**REQUEST FOR PROPOSAL
FOR
DESIGN AND MANUFACTURE OF RAIL CARS AND
RELATED SERVICES
SOLICITATION # 20CTRAIL-1**

ADDENDUM #1

Design and Manufacture of Rail Cars and Related Services
Solicitation # 20CTRAIL-1
Response to RFP Questions

DATE: 10/23/2008	DATE: 11/13/08
SCALE: 1/8"=1'-1"	SCALE: 1/8"=1'-1"
PROJECT NO. E 3453.03	TOWN NO. MNR-NO. 8
SHEET 1 OF 1	SHEET 1 OF 1

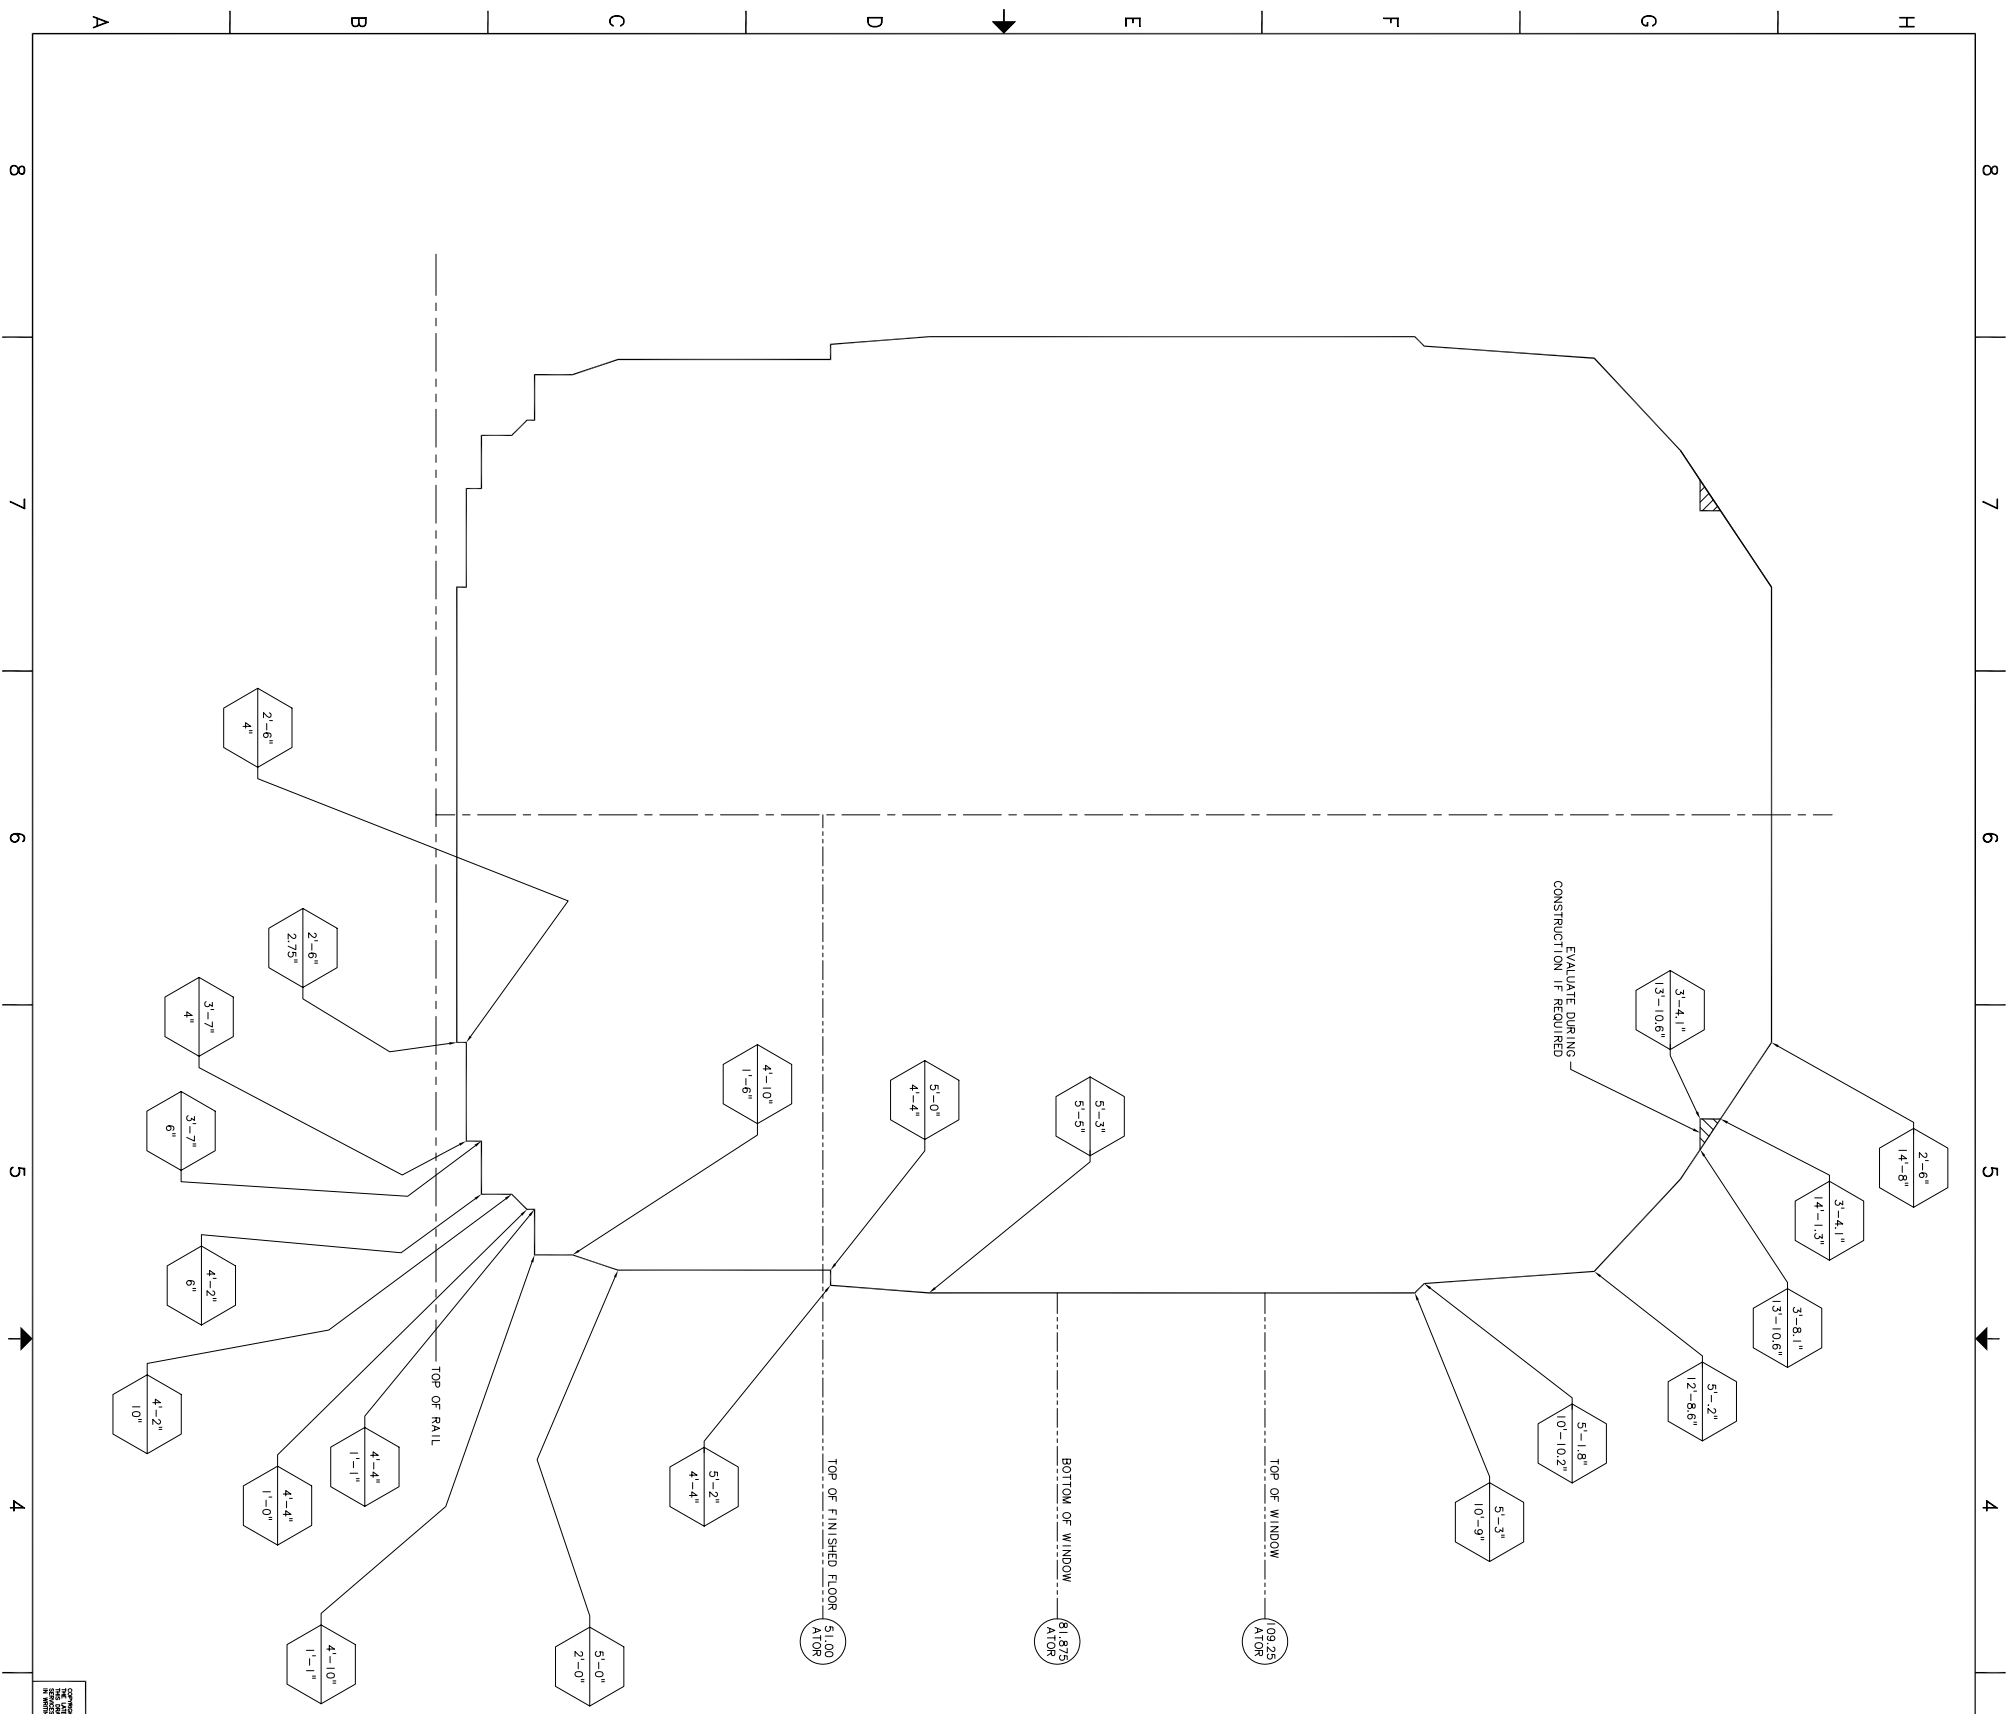
<u>Question No.</u>	<u>Part No.</u>	<u>Section Reference</u>	<u>Question</u>	<u>Answer</u>
20	4	1.04.03.B	Clearances The cars, including the F-end snowplow pilot on the cab car, shall fully conform to: 1. Drawing No. MNR-NO. 8, Rev. B 2. Drawing No. MNR-NO. 9, Rev. C. Can CTDOT kindly provide the referenced drawings?	Yes, attached.
21	4	1.04.03.C.3	Chapter 1.04.03 C.3 stated "The cars shall be capable of negotiating a 250 ft (76,200 mm) radius (18 degree) horizontal curve." Please clarify if 250ft is the revenue curve radius or the depot line curve radius, is it also it the minimum radius? If 250ft is the revenue curve radius, for a no-bolster truck design, the 8 ft 6 in axle base might lead to a faster wheel wear-out. If it's recommended to propose a no-bolster truck design, is possible to shorten the axle base? If 250ft is the depot or yard curve radius, please provide information about the revenue radius, i.e. curve radius between stations, the super elevation and cant deficiency data.	CTDOT confirms the 250ft is a depot curve. CTDOT requires a bolster truck design.

The completed car shall include all antennas and other devices mounted to the car, and shall fully conform to ~~PRHA Drawing 305-801~~ **Drawing No. MNR-NO. 8, Rev. B and Drawing No. MNR-NO. 9, Rev. C.**
